GENERAL	LOCATION OF PROJECT (ADDRESS) <b>1400 BURBANK AVE</b>	<b>Note: This form is for appeals of Department actions only. Appeals of Commission and Board actions are filed in the City Manager's Office.</b>		
	NAME OF PROJECT <b>BURBANK AVE SUBDIVISION</b>			
	APPELLANT NAME <b>MARK PARRISH</b>	DAYTIME PHONE <b>(707) 966-3227</b>	HOME PHONE ( ) -	
	APPELLANT ADDRESS <b>1806 BURBANK AVE.</b>	CITY <b>SANTA ROSA, CA</b>	STATE <b>CA</b>	ZIP <b>95407</b>

### **RE: BURBANK AVENUE SUBDIVISION CONCEPT STUDY**

**Subject:** Burbank Avenue Subdivision-PRJ19-031, MAJ19-003, DR19-054, CUP19-095  
**Attachments:** Attachment 12 - Roseland Area Sebastopol Road Specific Plan Circulation.pdf; Attachment 13 - Roseland Area Sebastopol Road Specific Plan Land Use and Housing.pdf

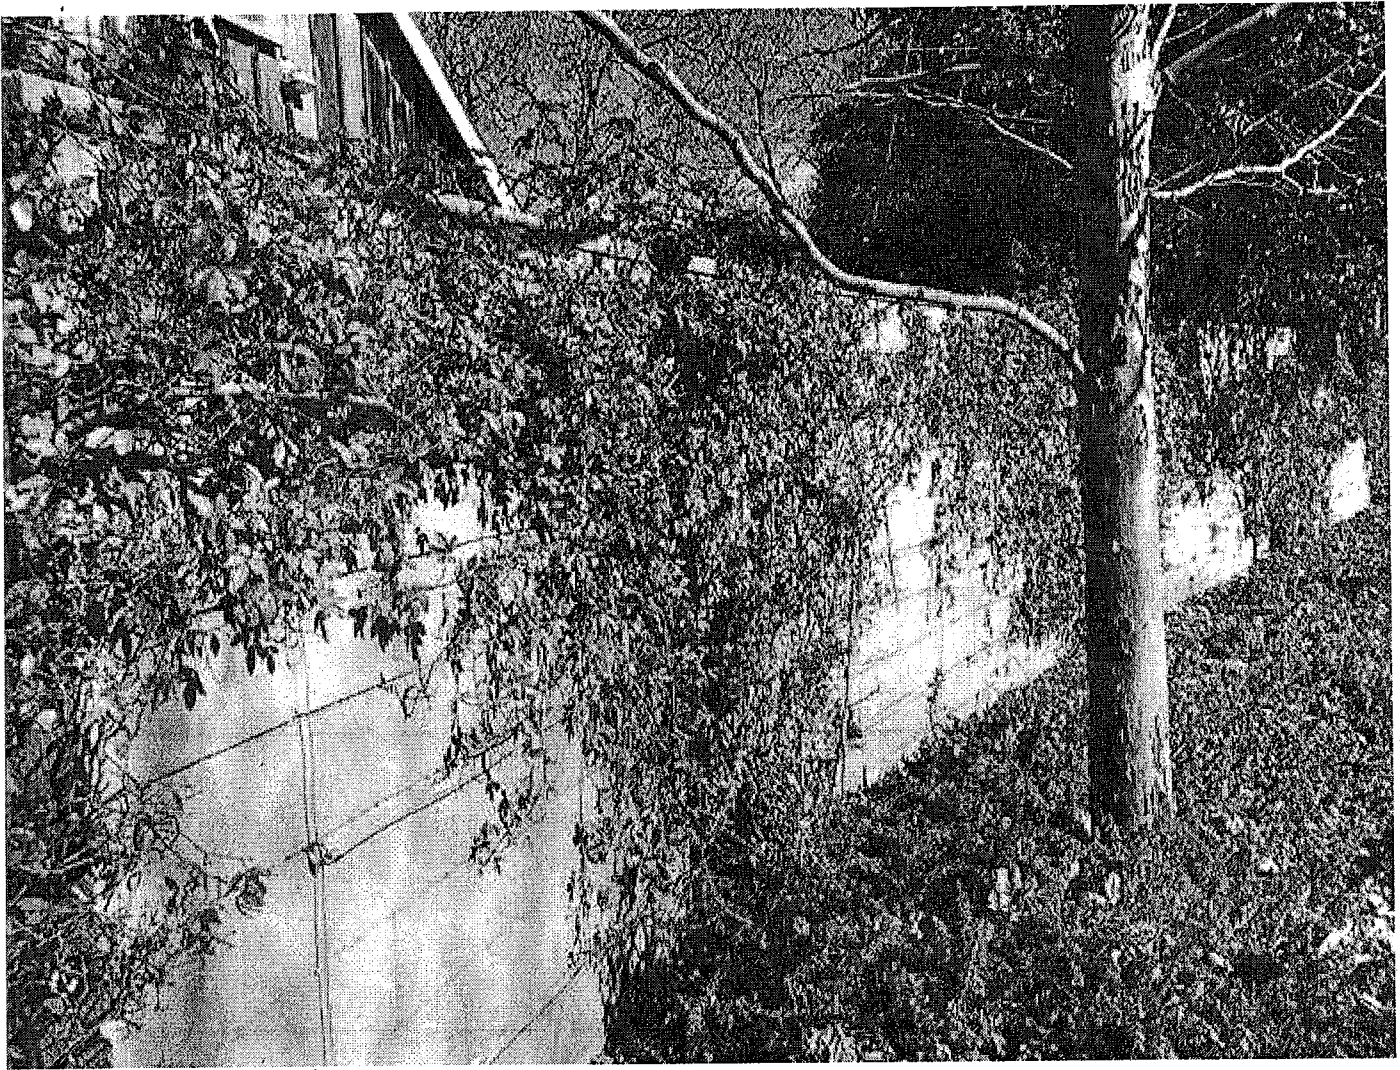
I am not against new housing projects as I understand we desperately need housing in our city, however, this project as currently designed is not appropriate for our rural neighborhood. As it maximizes the impact of the largest structure on existing tenants and Burbank Avenue itself by being placed along the fence line of existing neighbors to the South and within feet of Burbank Avenue to the West.

If this subdivision is to move forward without further appeals I recommend the apartments be located within the center of the project. That is the most sensible placement to meet the Policies and Goals laid out very clearly in the planning documents attached to the agenda of this meeting.

Placing the highest density component in the back yards of existing residents right on the fence line with parking and garbage pickup noise at all hours makes no sense. The proposal of a simple "good neighbor" 6-foot tall wooden fence rather than the Masonry Sound Wall required at many developments in the past does nothing to mitigate noise. This one pictured is at 1452 Mendocino Avenue which is where the current Chick-Fil-A is located today but it was required by Planning in 1985 when a Burger King restaurant was built there as the residents demanded it.

Also, if you must approve building on the fence line consider mitigation by facing the parking and access road for garbage trucks on the other side of the apartments away from existing neighbors and facing the center of the total project area.

In addition to hundreds of car movements per day along my fence line, dumpster enclosures will be located directly behind my home which will need to be emptied multiple times per week by refuse vehicles which most likely will have to back up using their loud beepers sounding increasing noise and disrupting our peace along my property line. We respectfully request that additional options for adequate noise buffering, including but not limited to, a masonry wall, or placing said access road on the other side of the building facing internally be considered as mitigation measures.

Where is lighting proposed throughout the site and when can a conceptual lighting plan be provided? Because the proposed service road is just north of our property, we would like to ensure that the area is lit for safety, but in a manner that is unobtrusive to our home and our adjacent properties where we raise our goats and chickens.
